**CCO #28-013**

Project: 0483-01 - Perris High School No. 4
32255 Leon Road
Winchester, California 92596

Change Order #28-013: Cat. 28 PCO #'s 021, 028, 029, 035, 036, 037, 039, 040, 041 - Board Approval Required

[Berm at Meadowgate.pdf](#)

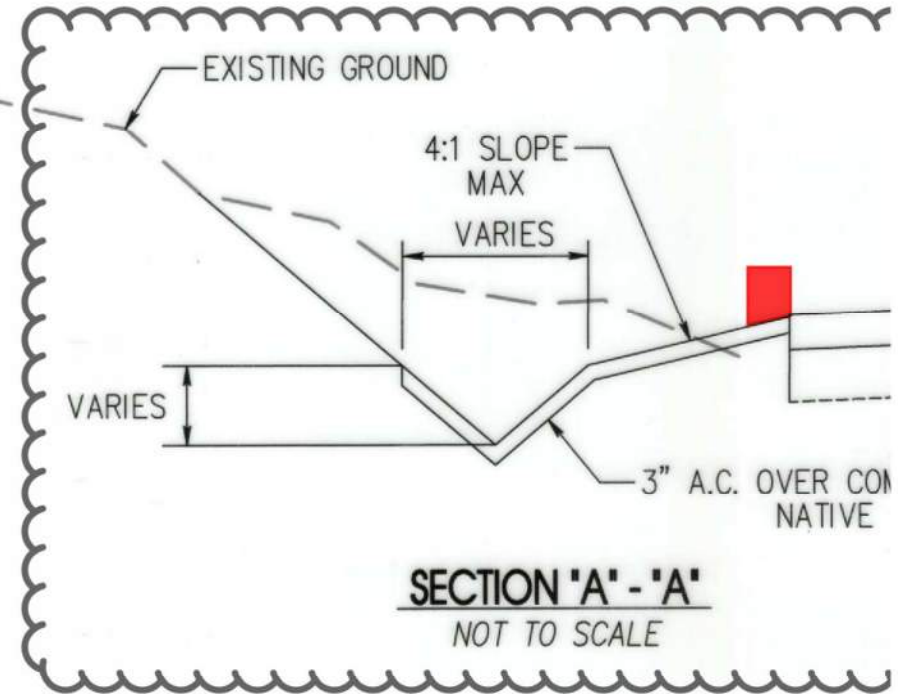
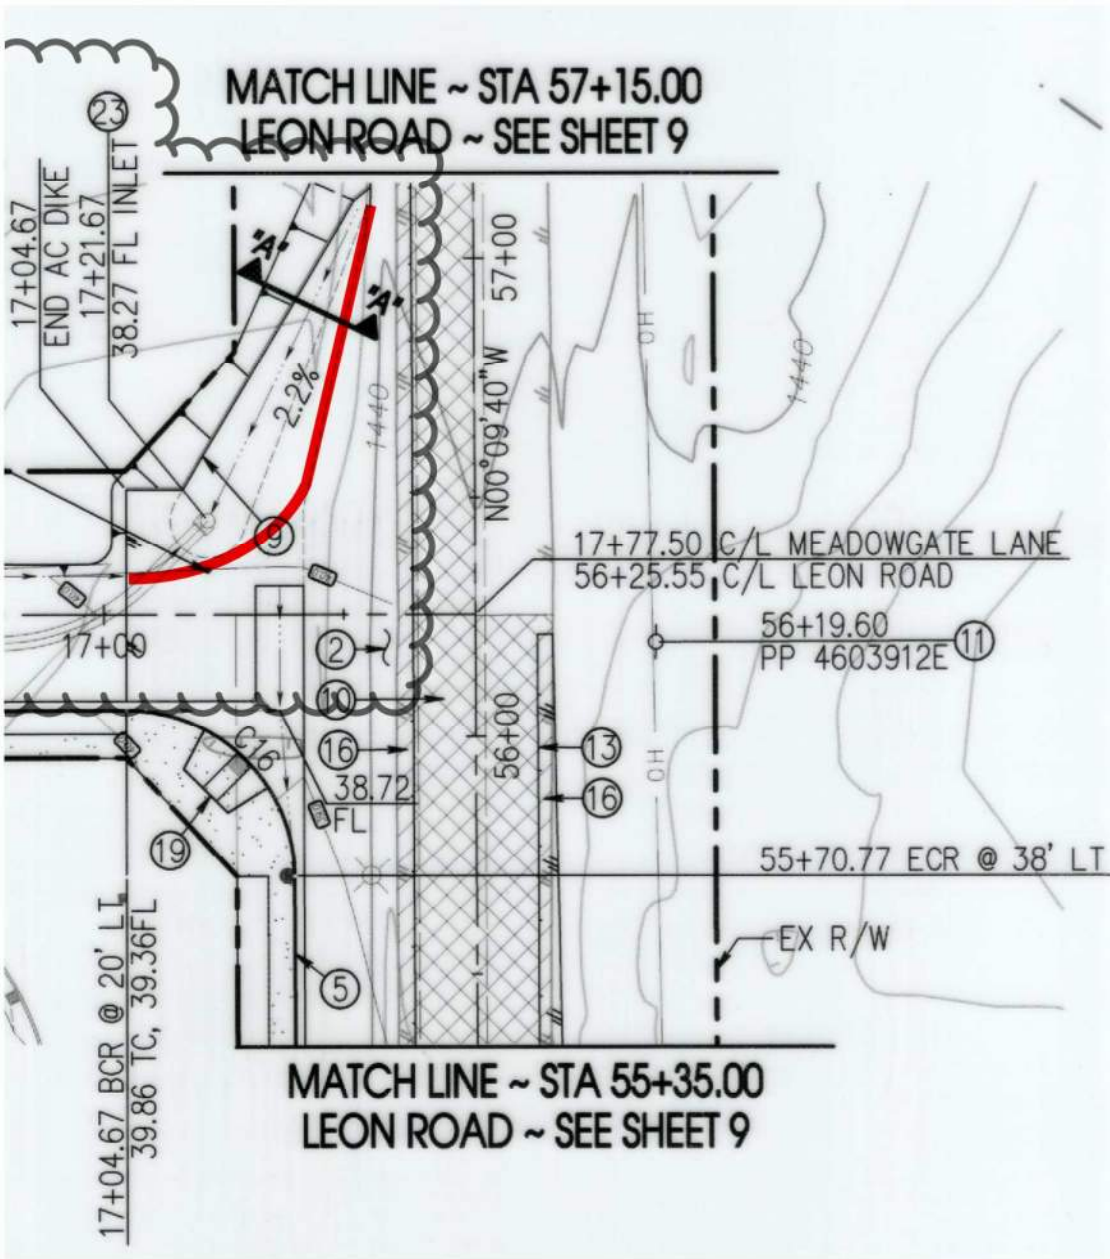
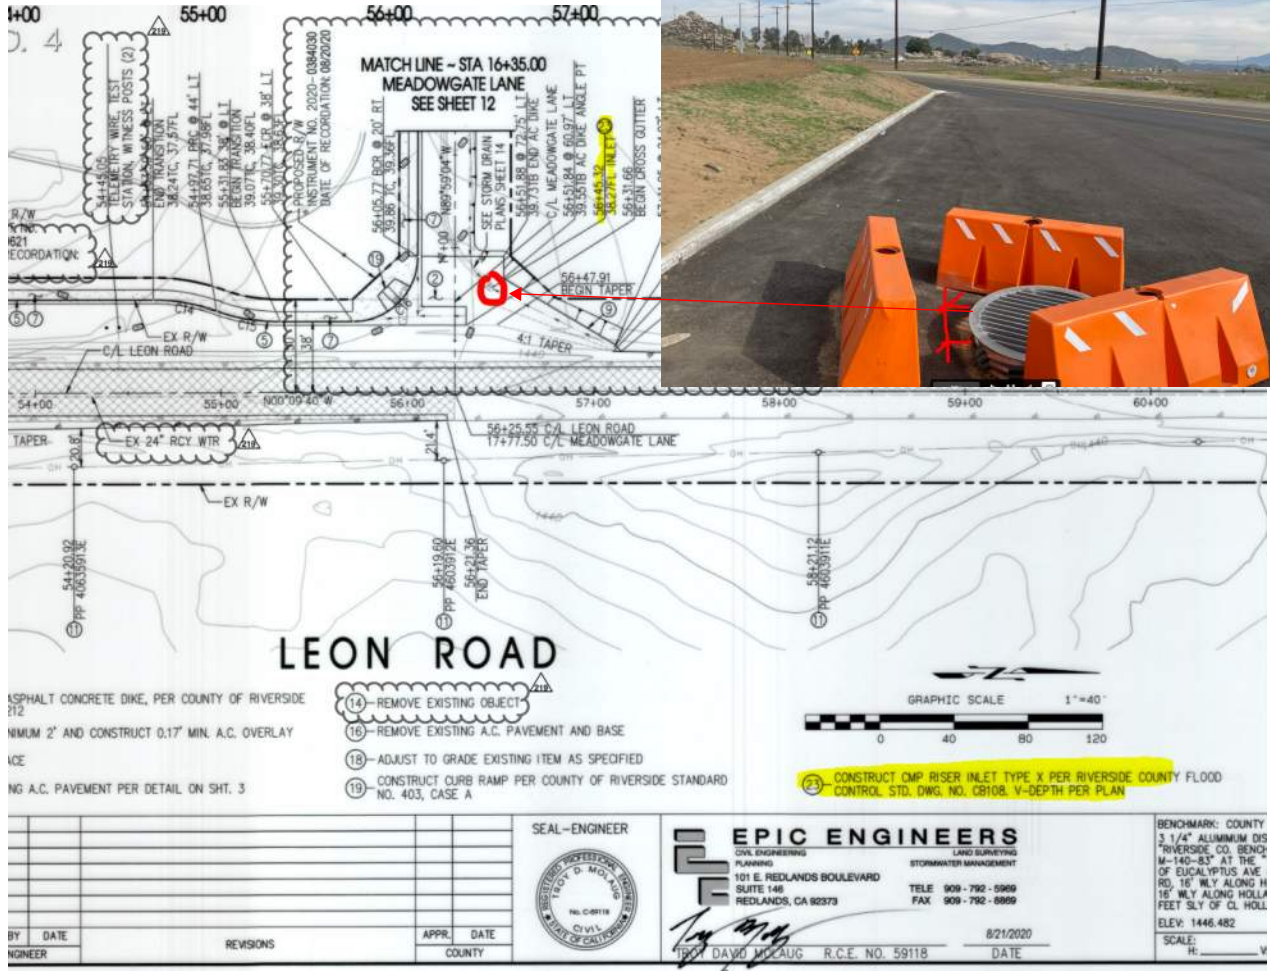
At the North-West corner of Leon Road and Meadowgate Lane, Civil drawings specify the installation of a CMP riser inlet per Riverside County floor control standard drawing CB108. The as-built condition with no protection poses a concern for vehicular and pedestrian traffic. Please see the attached picture, highlighted location, as well as the standard County drawing CB108 for reference. Please review and advise if further direction is to be provided to the Contractor.

Per coordination with Saleem Baig at the County Transportation Department, "Place Asphalt Concrete Dike (CRS 212)(8)" as shown on the attached marked up snapshot of our original plan, the face of which being at the location of the grade break.
